TO: Khadeja Sarwar, Atwell, LLC
FROM: Amber Wood Hicken, Planner I
DATE: 4/9/25
SUBJECT: Parker Pointe, Black Rock Coffee, Site Plan
Review Comments 02

BLACK ROCK COFFEE BAR
 13135 DECLAN DRIVE
BLACK ROCK COFFEE BAR
 SITE PLAN

BLACK ROCK COFFEE
MODULAR BUILDING

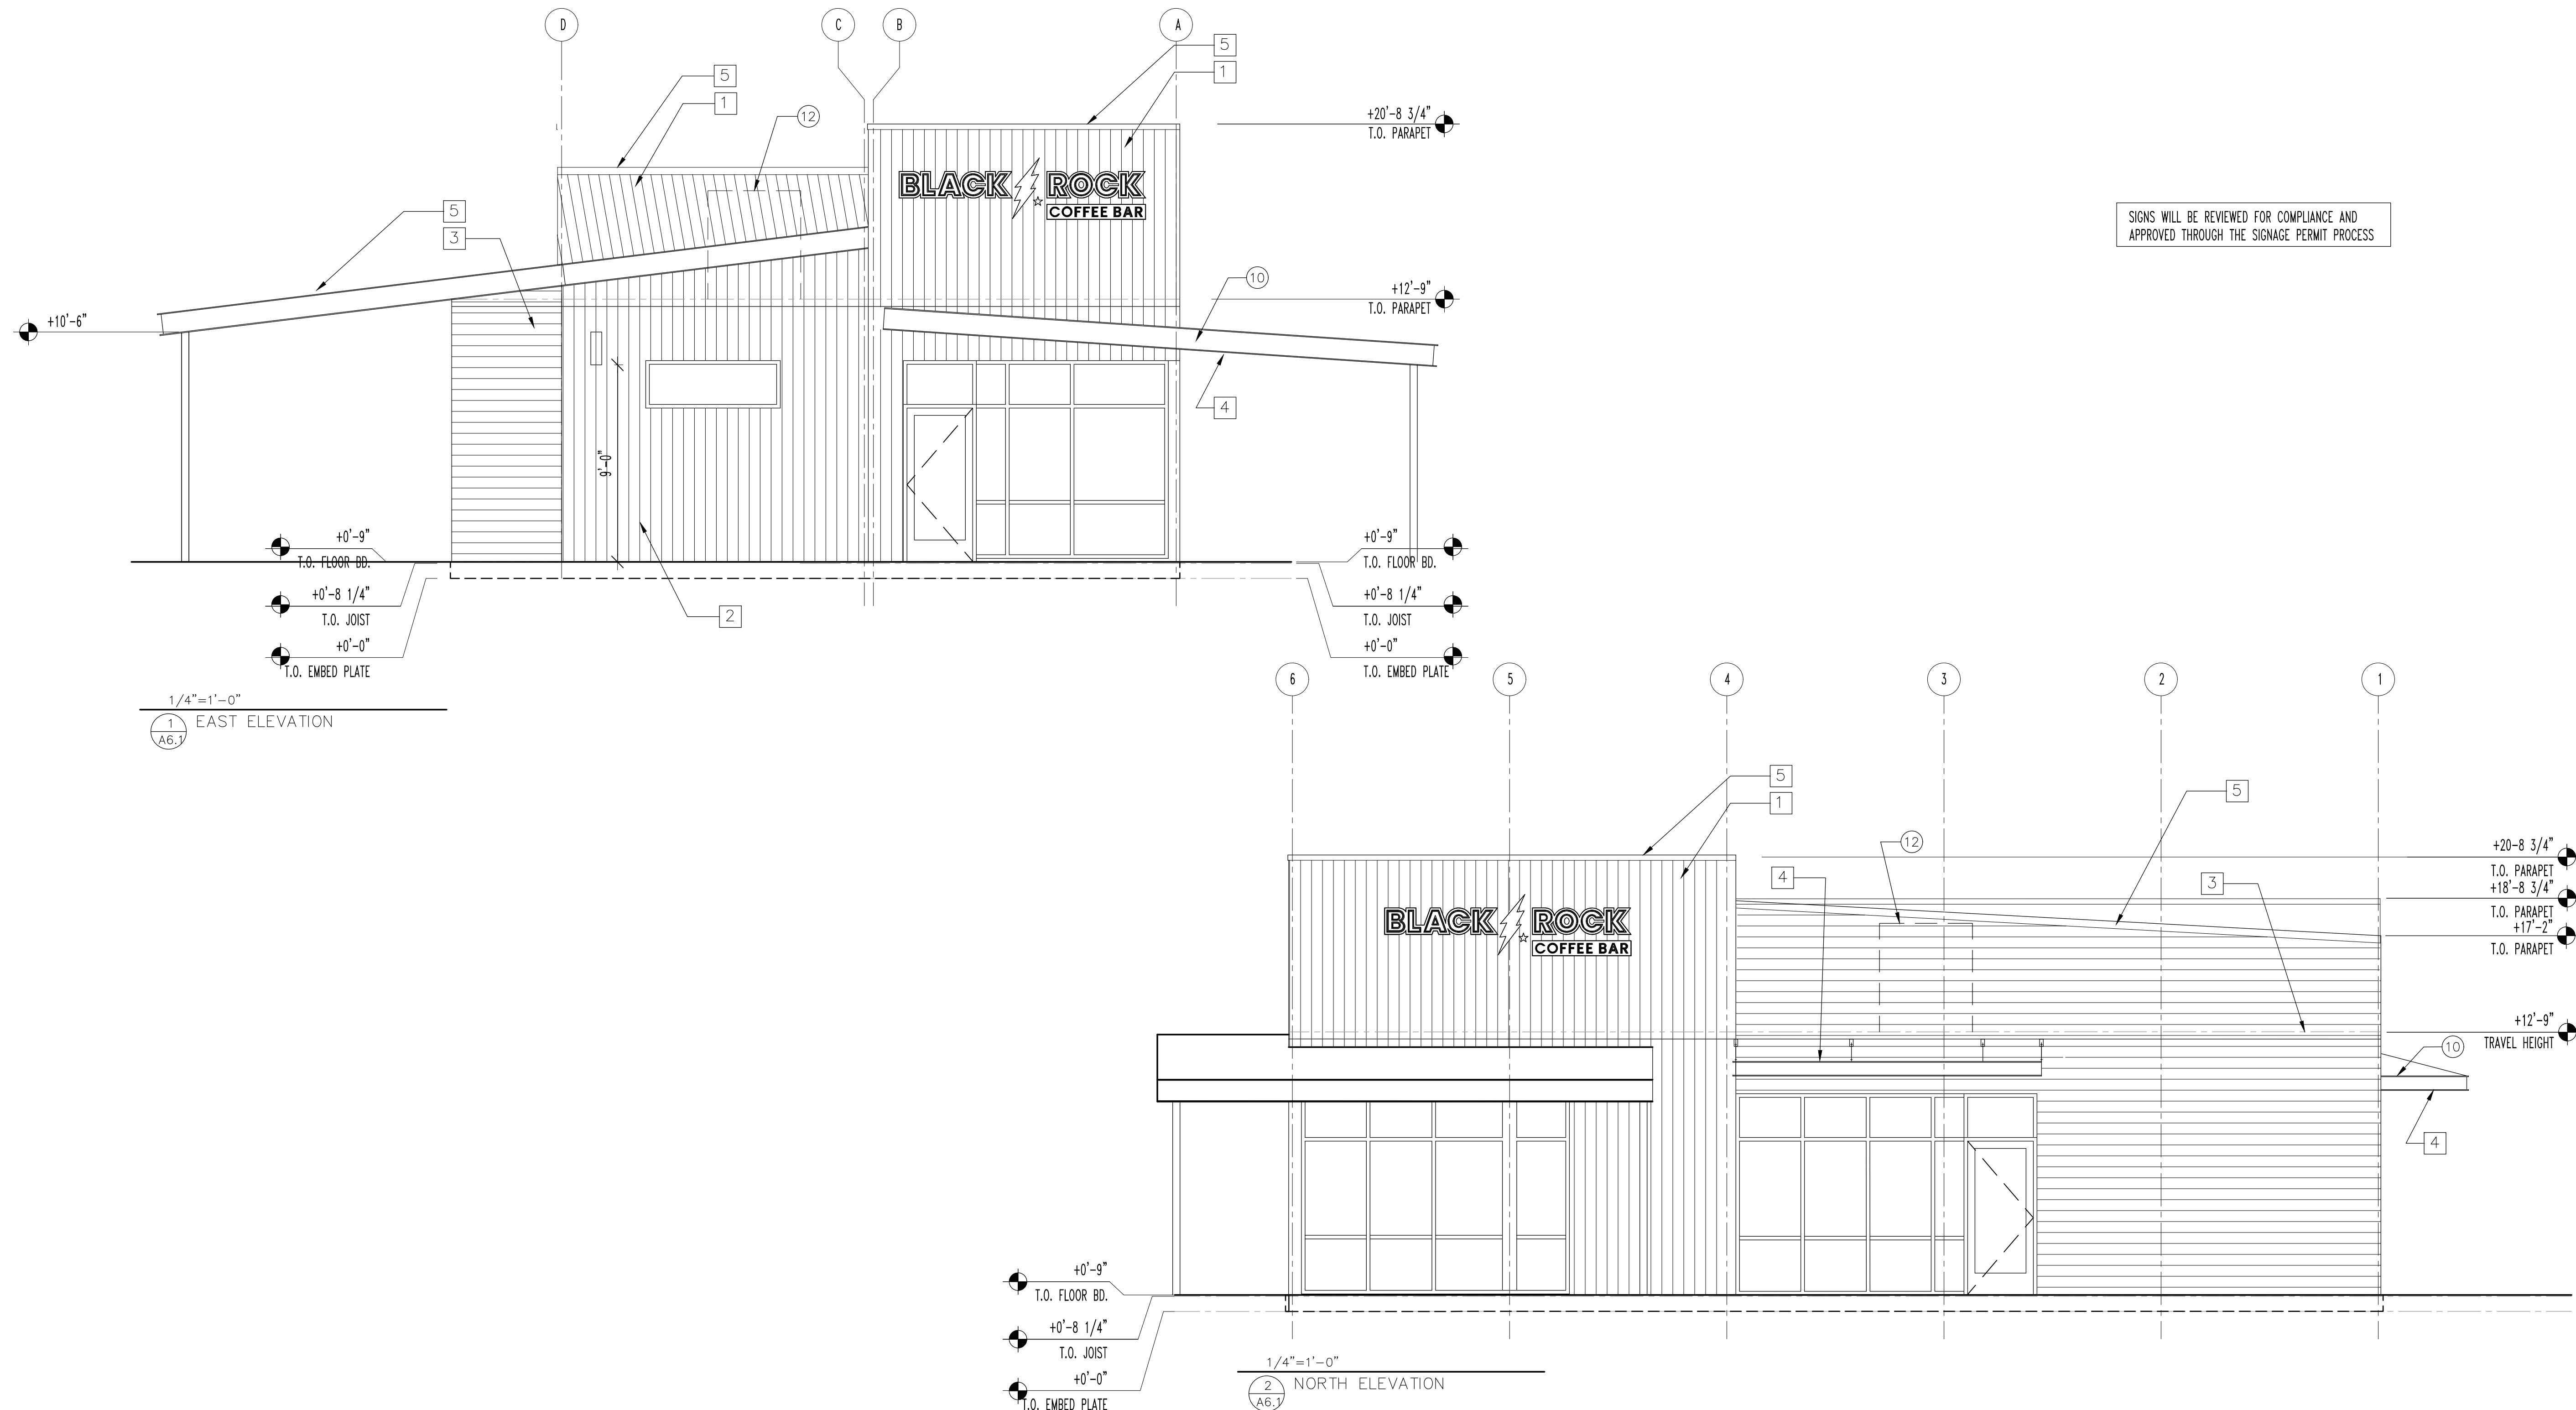
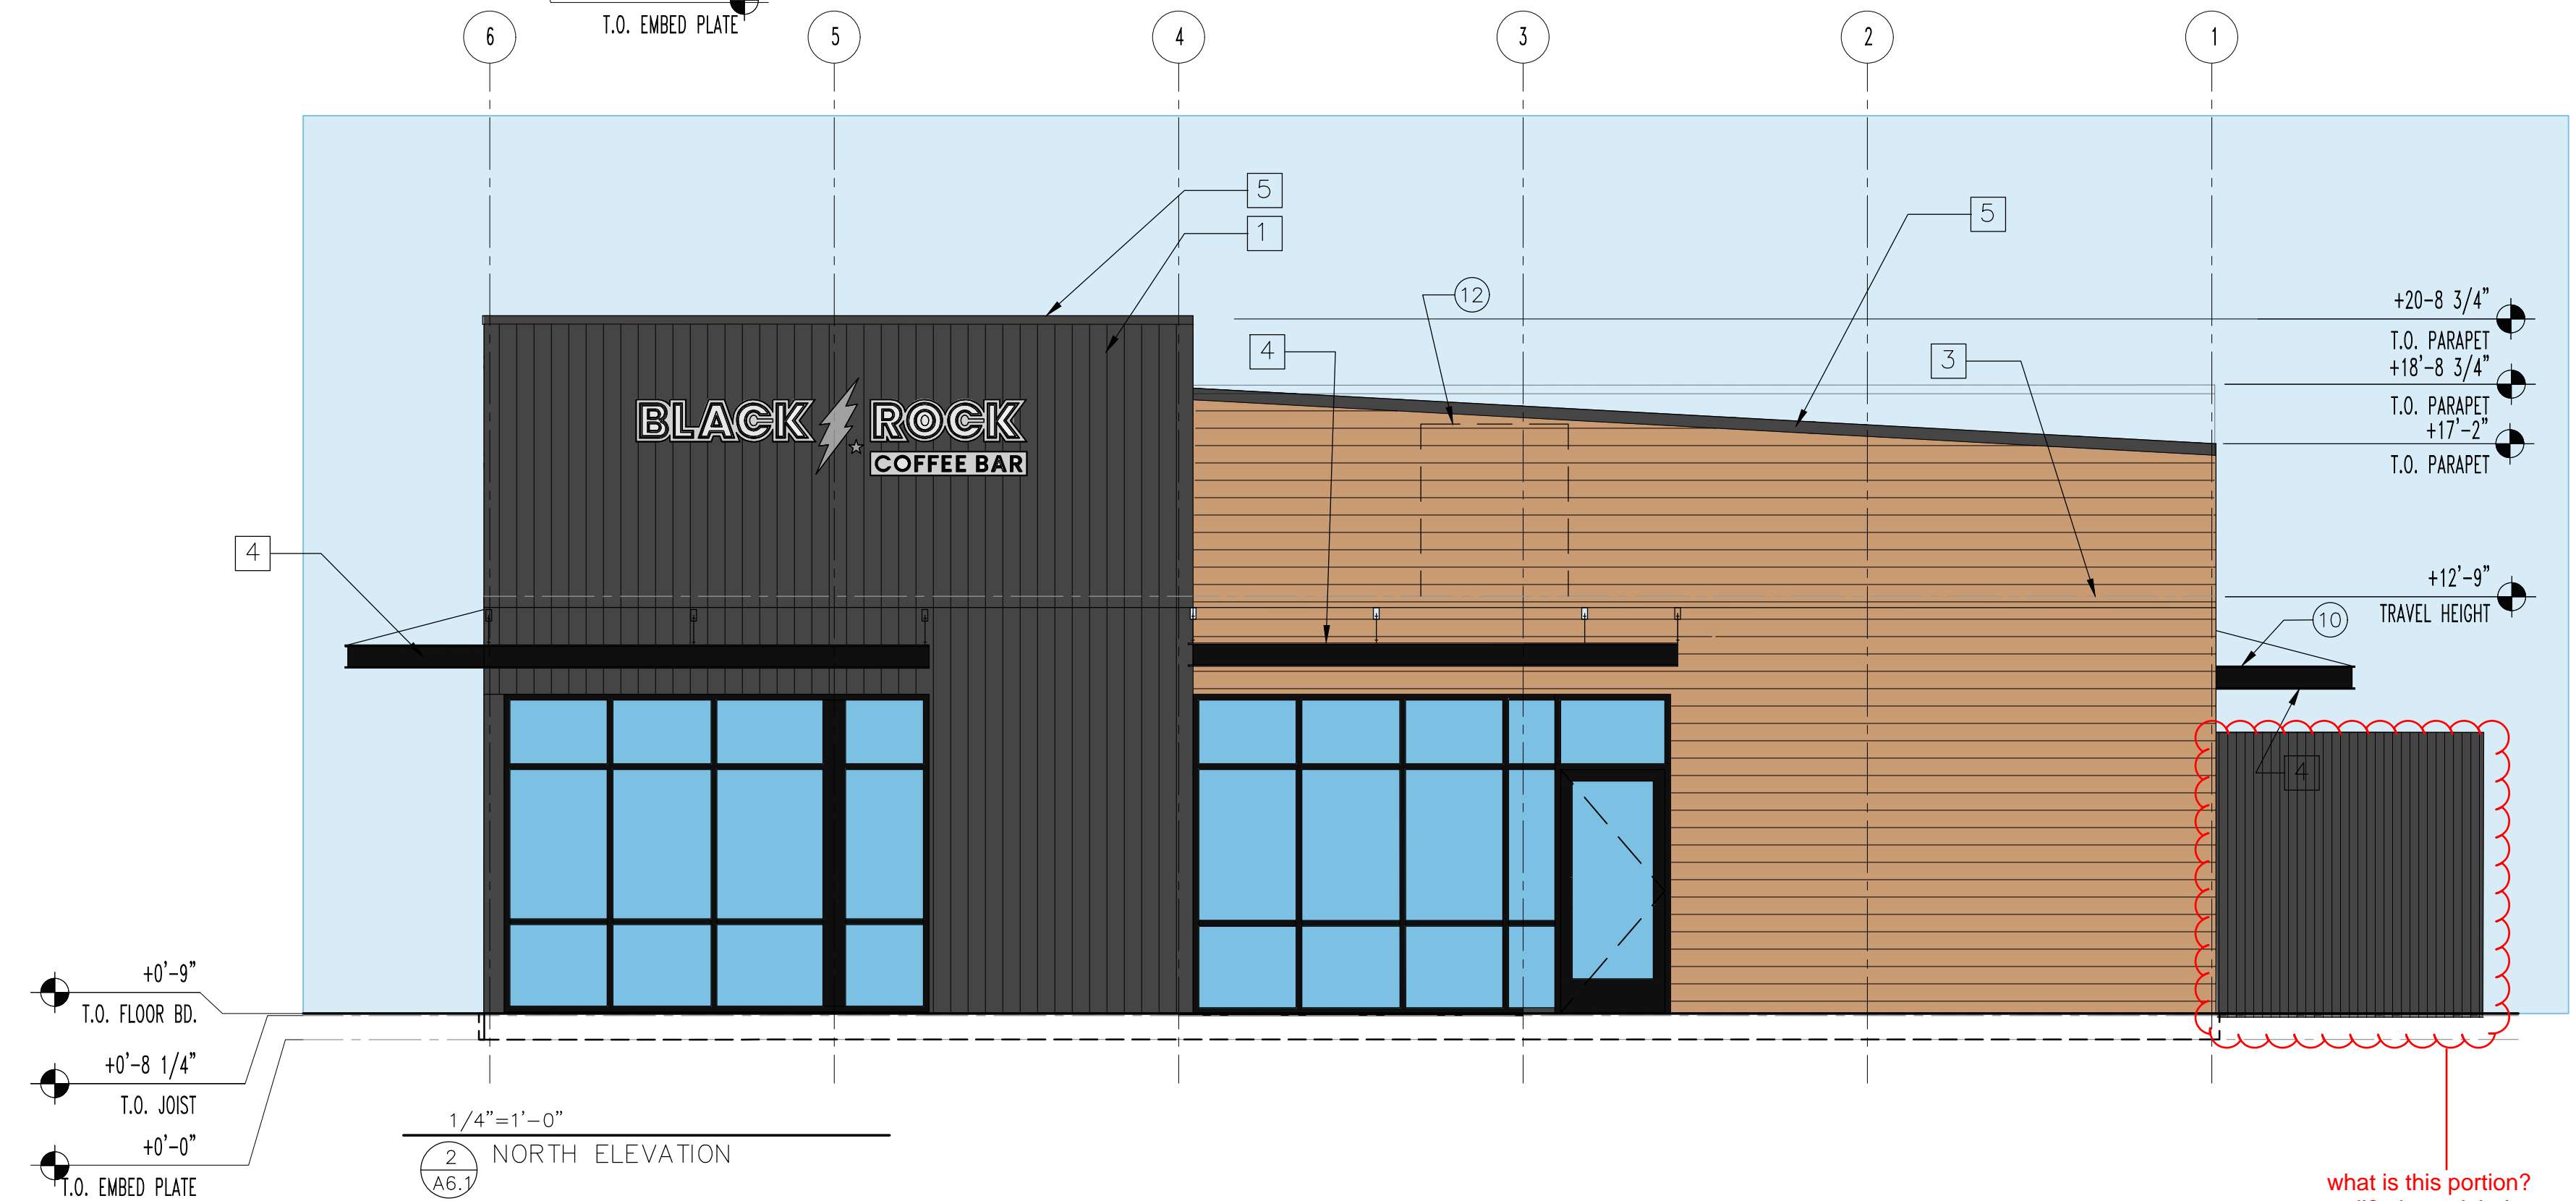
#13 electric meter not shown. please show on elevations, add note that it will be painted to match adjacent wall

#14 screen wall not shown. this should be shown on elevations and site plan.

architecture needs to be enhanced. only two materials used on entire building - add more materials, possible corner feature on parker road, etc.

what is this portion? wall? please label, show on all relevant elevations.
